PROJECT
The Medical Center of Aurora
Hybrid OR 9
1501 S. Potomac St.
Aurora, CO 80012

Revision #1-5: Date of Issuance: 3-3-2021

Project Number: 190318

The items below are revisions 1-5 to the original Construction Documents dated 01/14/2020. Revisions described below and indicated on the attached revised plans:

SHEET NO.:
ED101

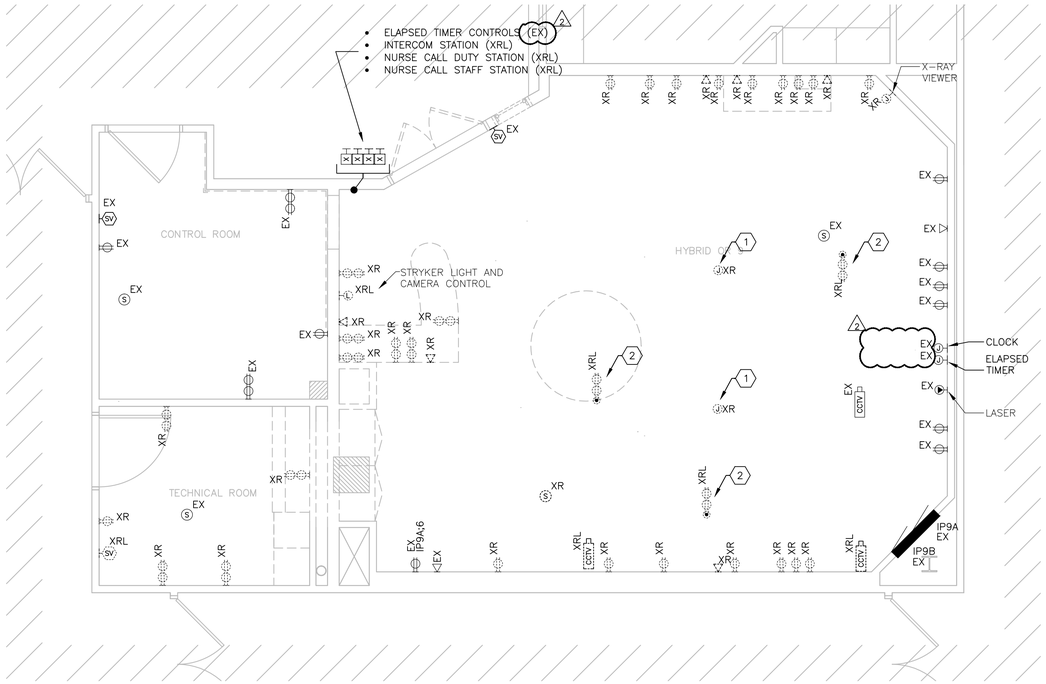
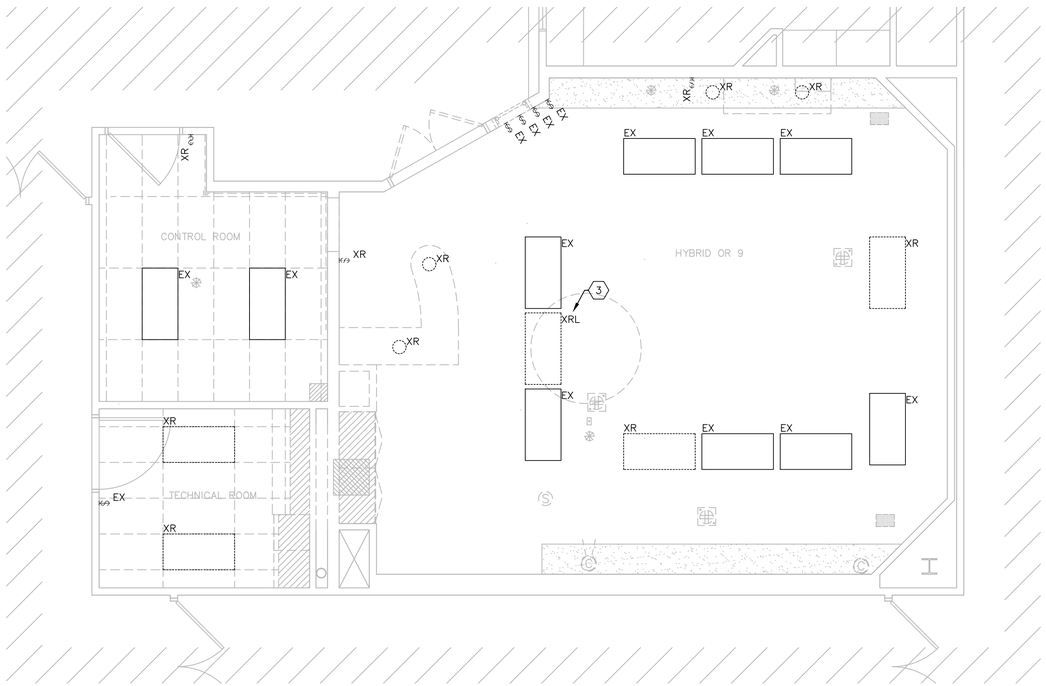
1. Existing wall mounted clock & elapsed timer to remain

1 ELECTRICAL RISER DIAGRAM
N.T.S.

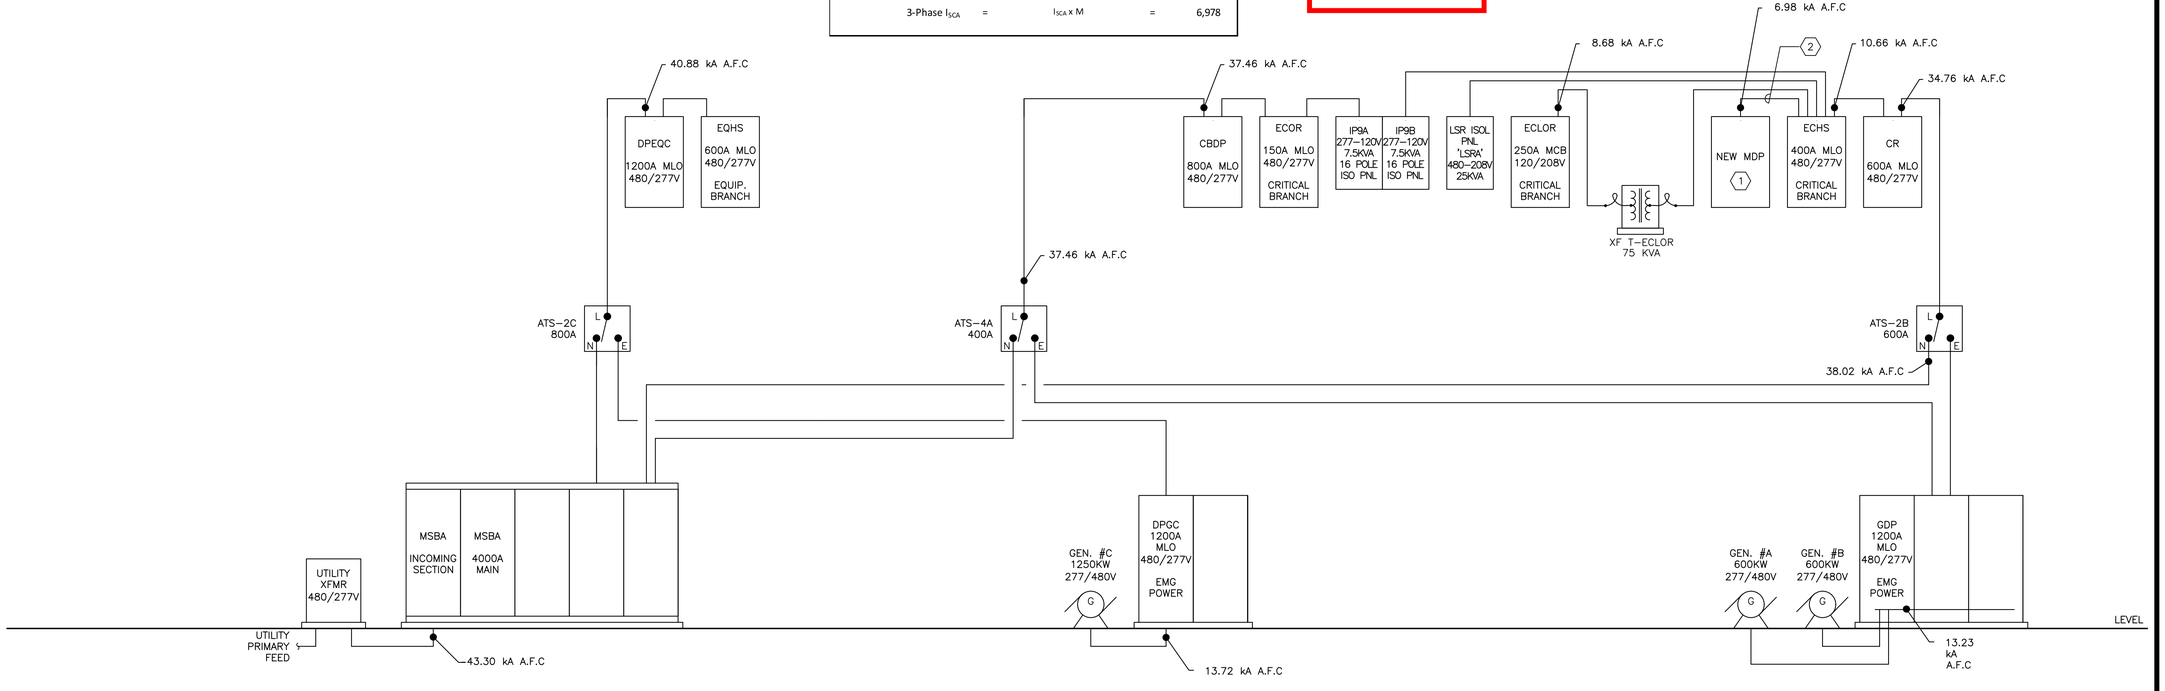
ELECTRICAL		
Comment #		
1	Comment:	Panel Schedule for ECLOR is not labeled as ECLOR. Need AIC rating of panel.
	Response:	Drawings have been updated to correct the cut off graphics which obscured the panel name and AIC rating. Revised sheet(s): E003
2	Comment:	Need panel schedule for new MDP and AIC rating.
	Response:	Drawings have been updated to include the panel schedule for MDP. Revised sheet(s): E003
3	Comment:	Need point to point fault current calculations starting from Xcel's transformer to panel MDP.
	Response:	Point-to-point fault current calculation and calculated fault current values added to riser diagram. Revised sheet(s): E002

1 ENLARGED OR PLAN - POWER AND SIGNAL

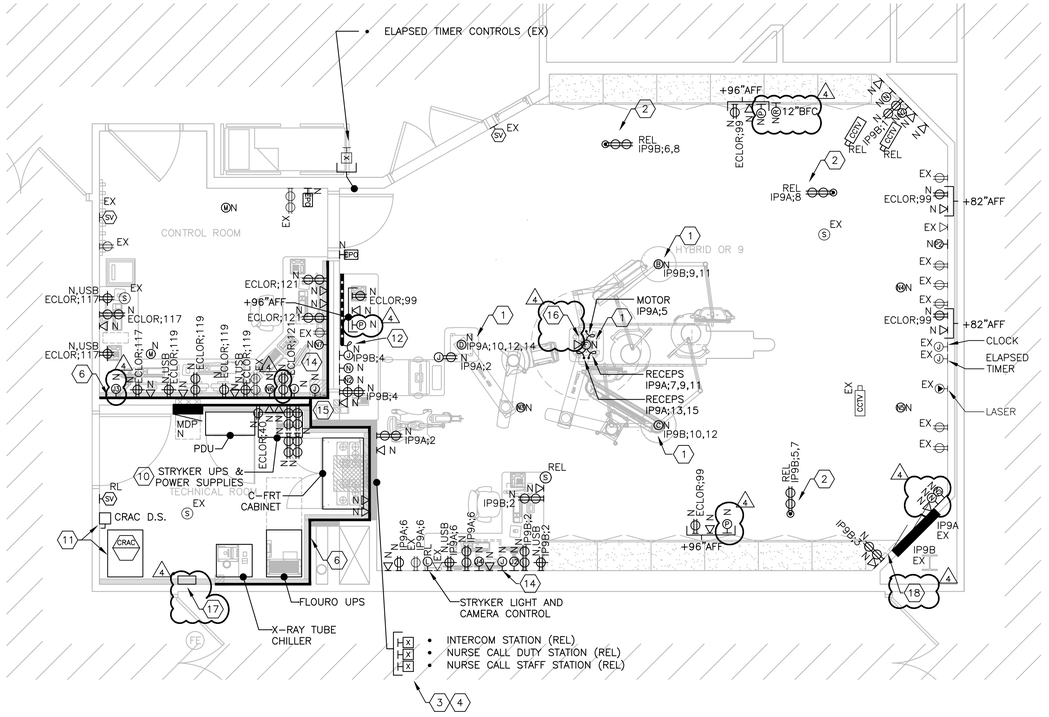
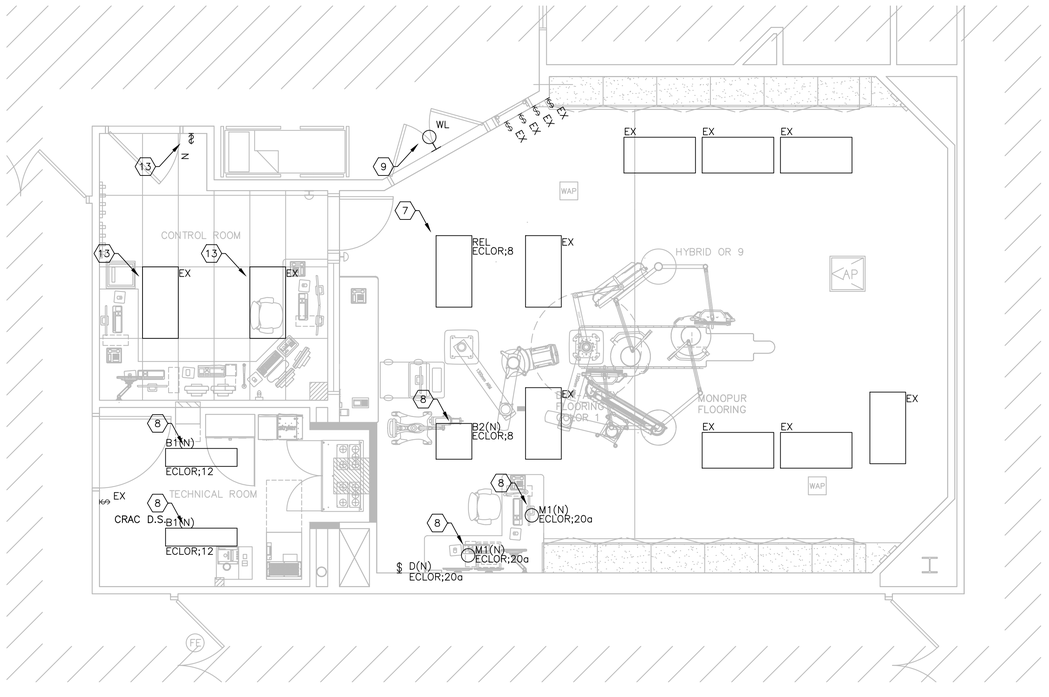
1. Plan note change

1. Addition of ground bus in the equipment room with clarification on the grounding requirements for GE/Stryker conduits.
2. Updated conduit schedule (The only changes are names. No conduit sizes changed)
3. Addition of J3 box in control room.
4. Addition of P box above window in OR.
5. Clarified mounting height of the other P boxes and R box in OR.
6. Updated conduit schedule with missing conduits.
7. Adjusted locations of boxes shown under isolated panels to aid in installation.
8. Added conduit for future Ethernet to monitor boom.
9. Added duplex receptacle in control room.
10. Revised the specification of lighting fixture M1.
11. Increase the size of the 2” conduit from the control room to the operator workstation to 3”.
12. Added ground lug for the flooring.
